Re: RC195114 - 29 Southbrook Road/32 Coronation Street

We refer to your request of the 18 May and respond (and apologies) as follows. We would note at the outset that there are now two site layout options and both will form part of the amended consent and the updated TIA. The amended plans and TIA are attached to this response and a fully amended version of the consent document will be forwarded.

PROPOSED COMMERCIAL DEVELOPMENT 29 SOUTHBROOK ROAD

STORMWATER AND FLOOD RISK ASSESSMENT

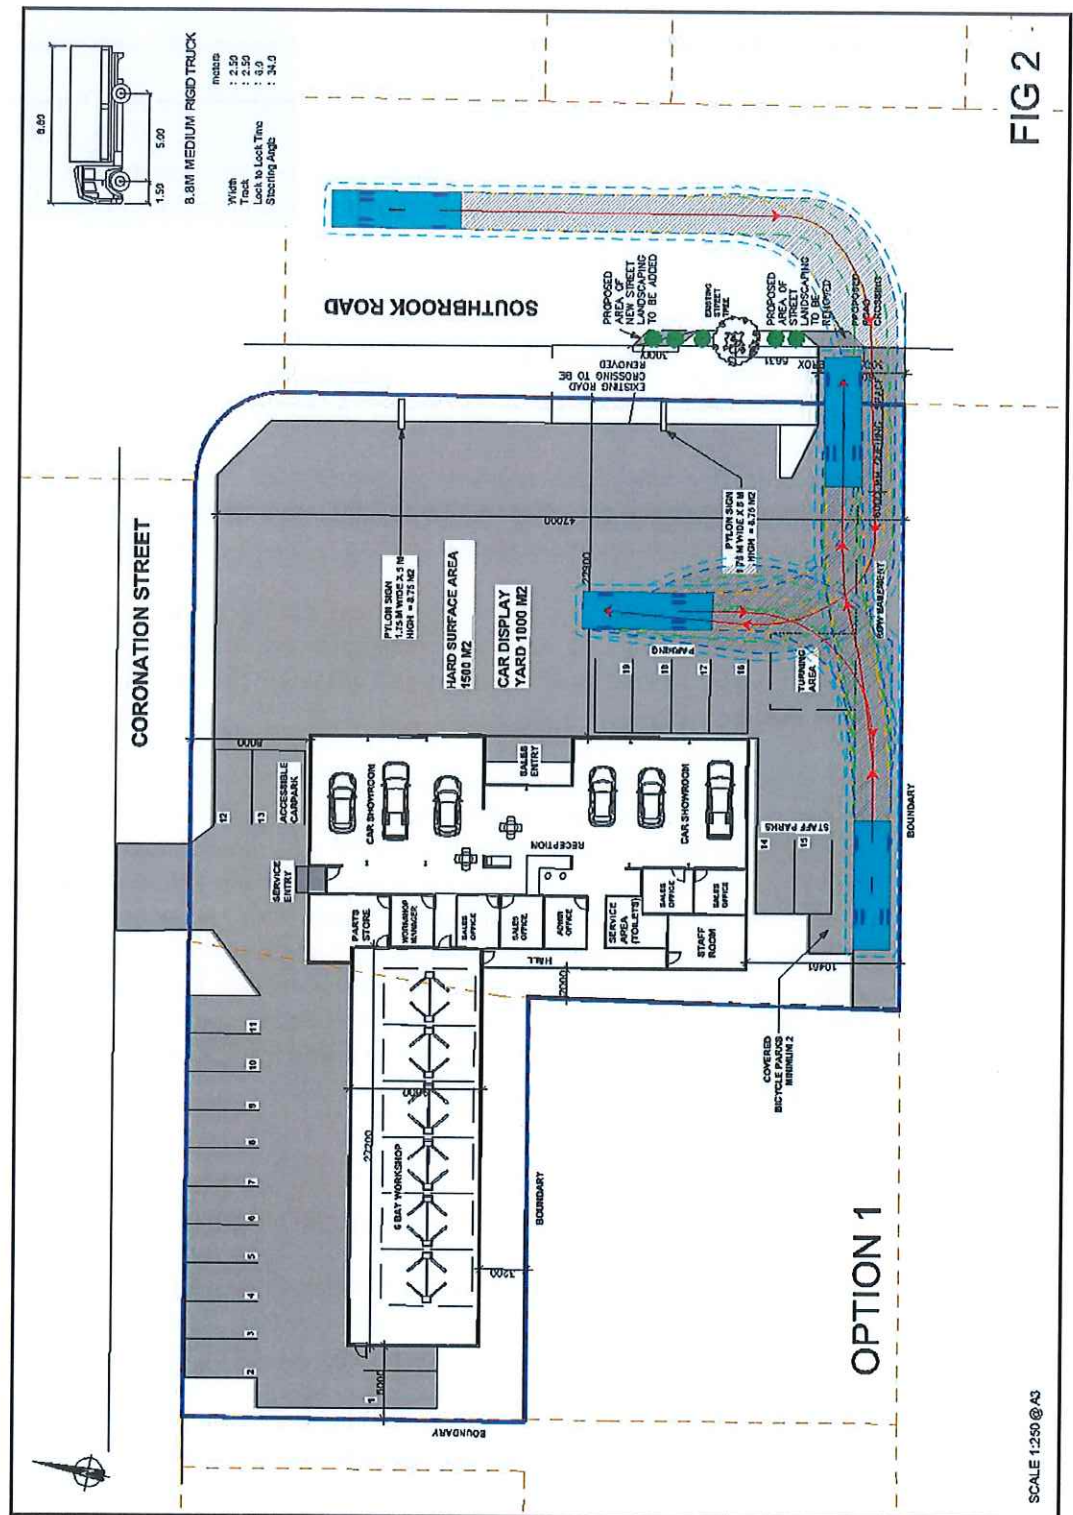
There will be no reversing on or off the site. This is addressed in the updated TIA (Aug 2019) on page 12, Para 4. In both layouts there is adequate space for vehicles to manoeuvre and

trucks can turn (Refer Fig 2, page 9). As such all vehicles can exit the site in a forward direction.

No loading bays are proposed (page 10, Para 5). Large trucks (11m) can turn (Fig 2) and leave the site forward. They will not use the Coronation St entrance. There is no bulk oil delivery and most deliveries come by way of "courier" size vehicles. The site does not do major repair work but rather the standard service requirements for vehicles. In addition "new" cars will not be delivered to the site by car-transporter. They will be driven to the site. A condition to this effect is offered in Annexure I.

Figure 3 indicates the internal layout proposed for Option 2.

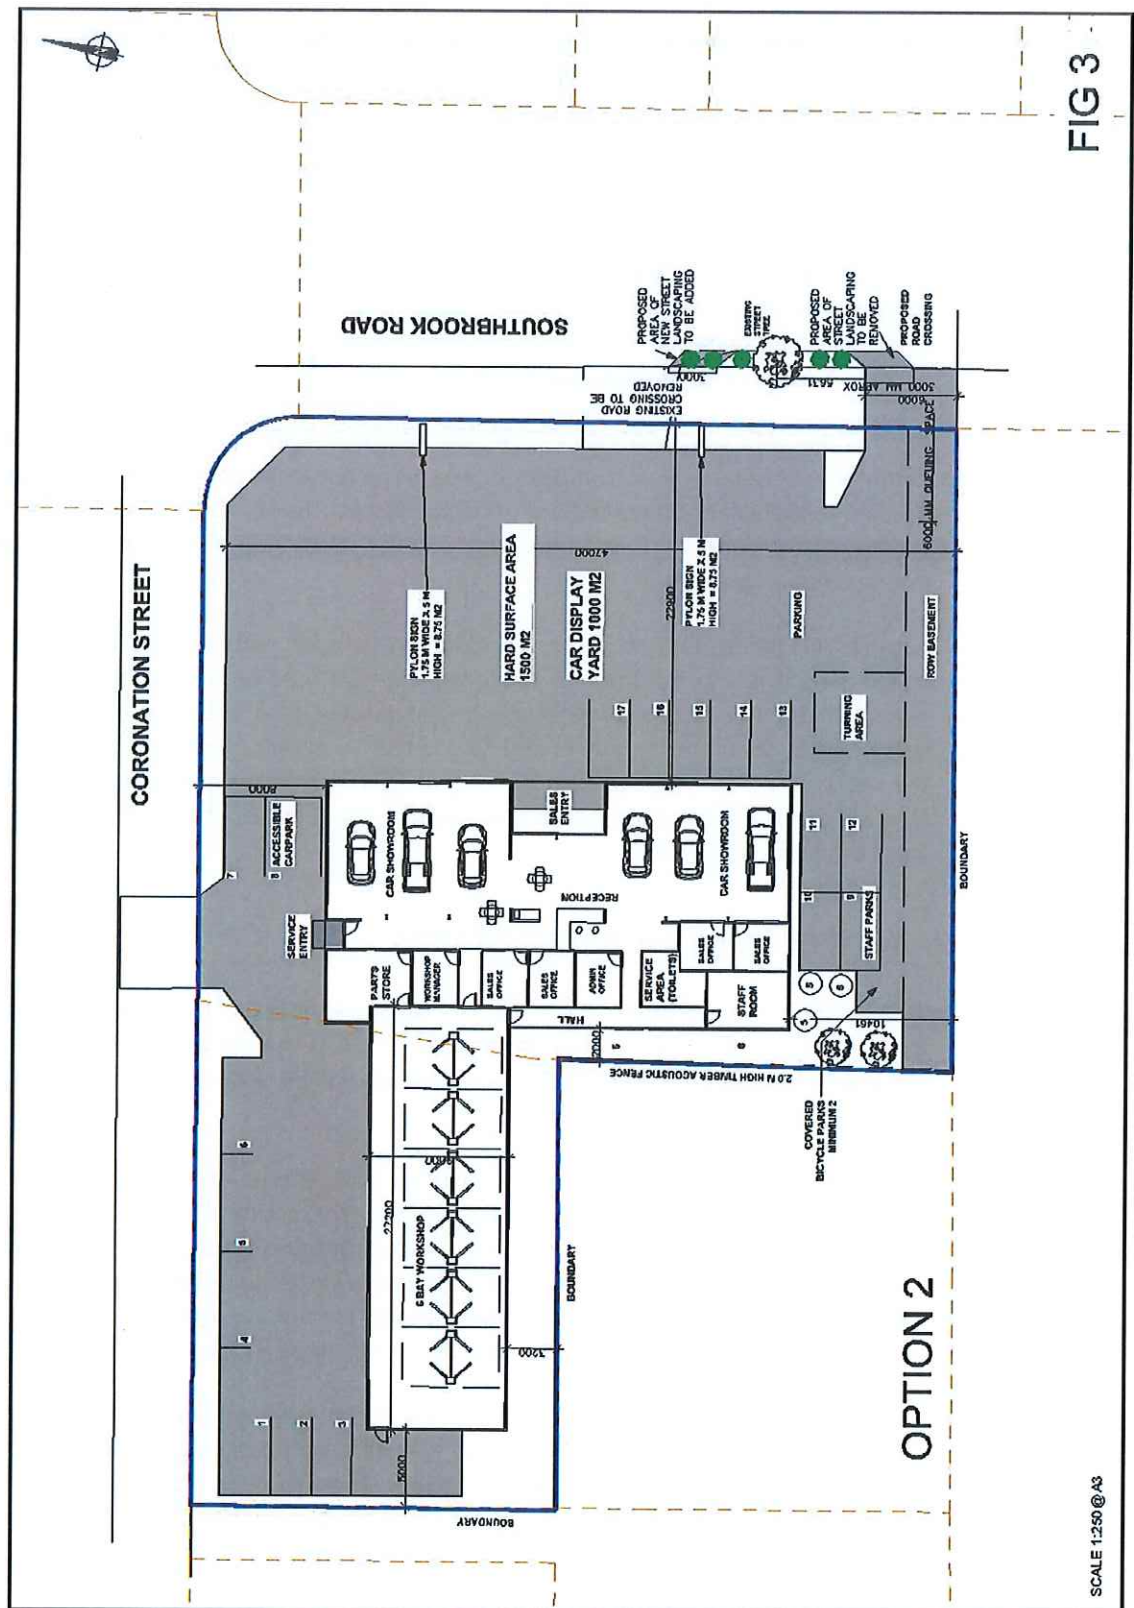
No cars are stacked in front of spaces 1-3 in Option 2, (page 15, Para 2) and will not block the fire egress door (page 10, Para 3).

OPTION ONE

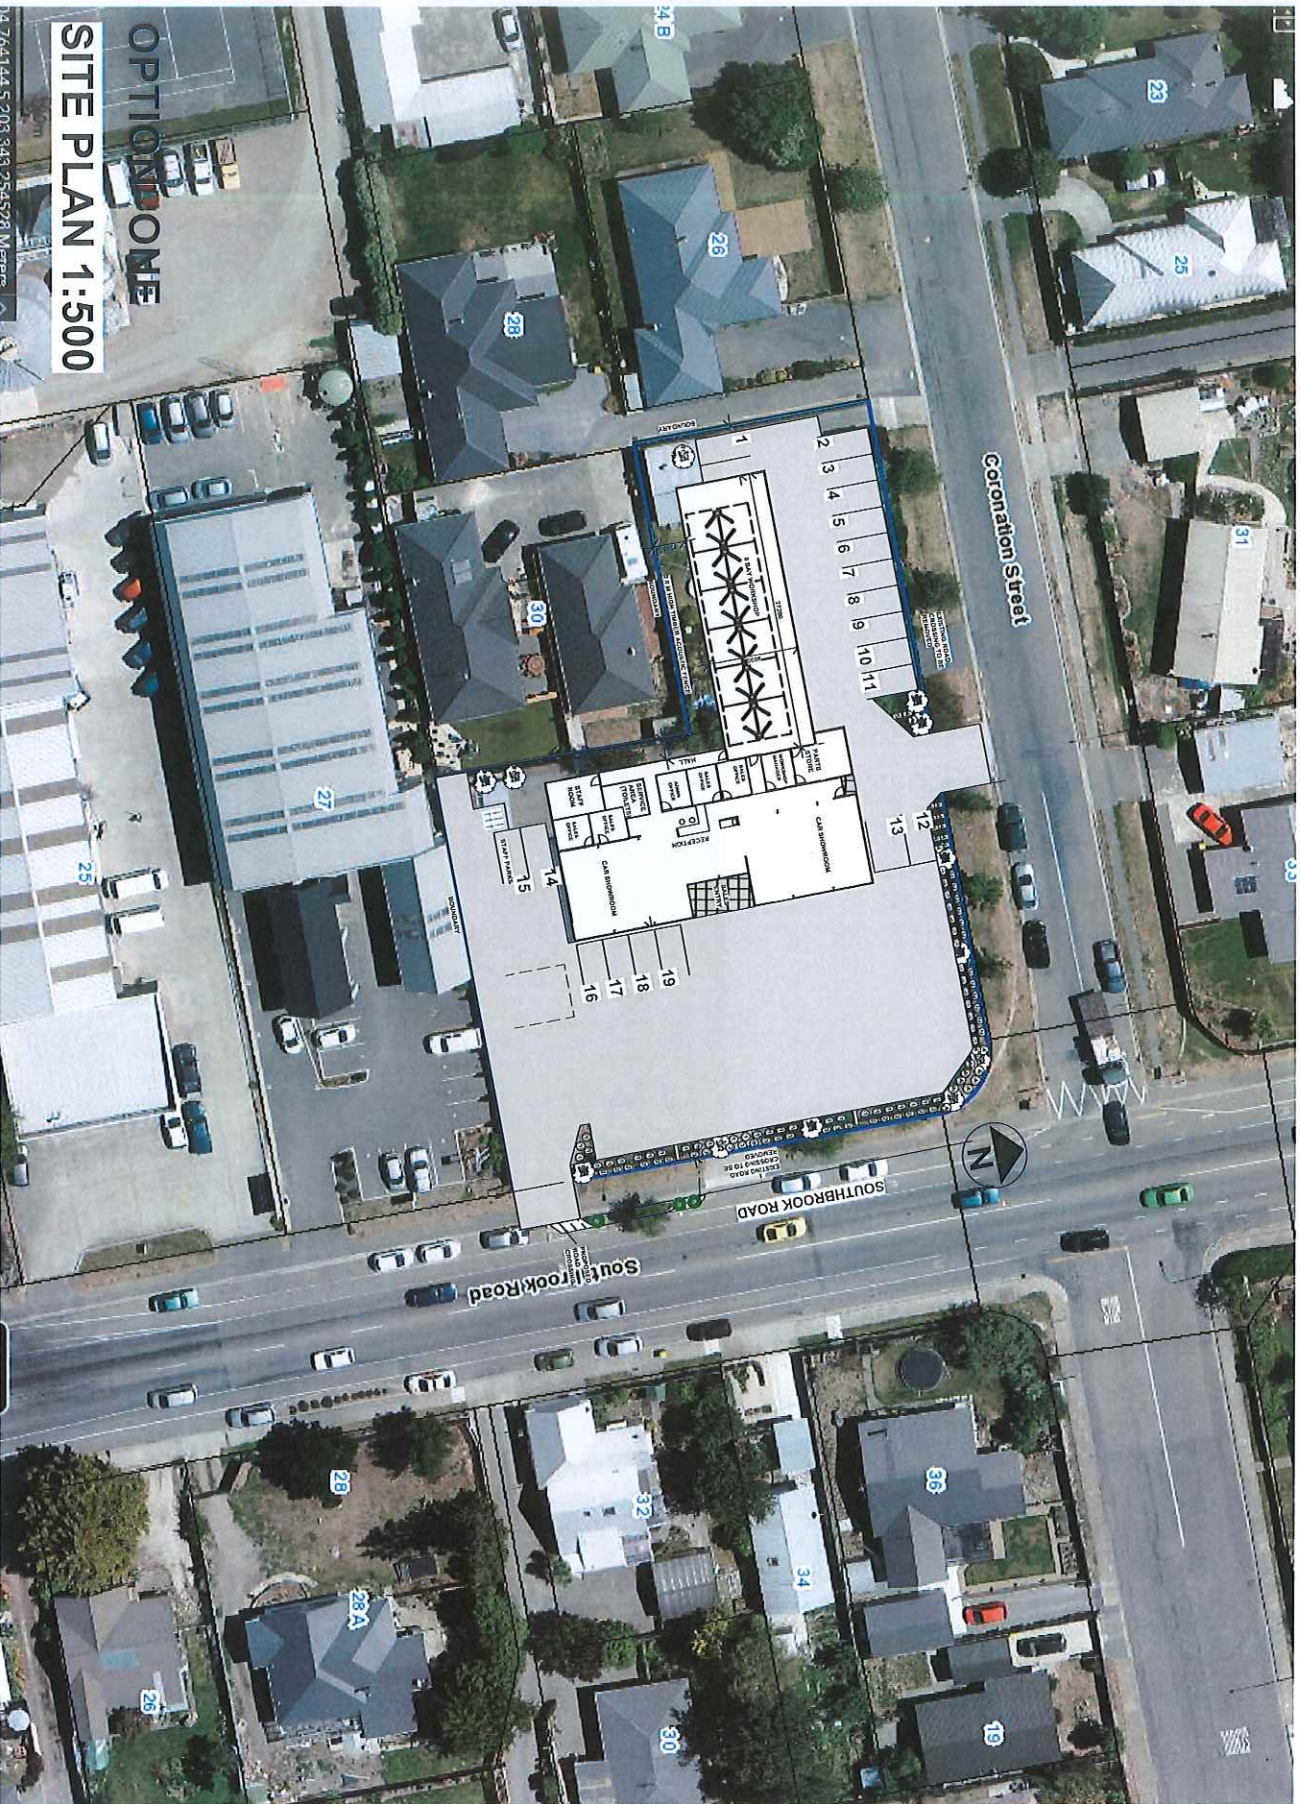
Re Option 1, the fence has been moved back into the site to allow the Pittosporum golf ball wedging to be located within the site. We have attached a replacement set of plans for Option 1.
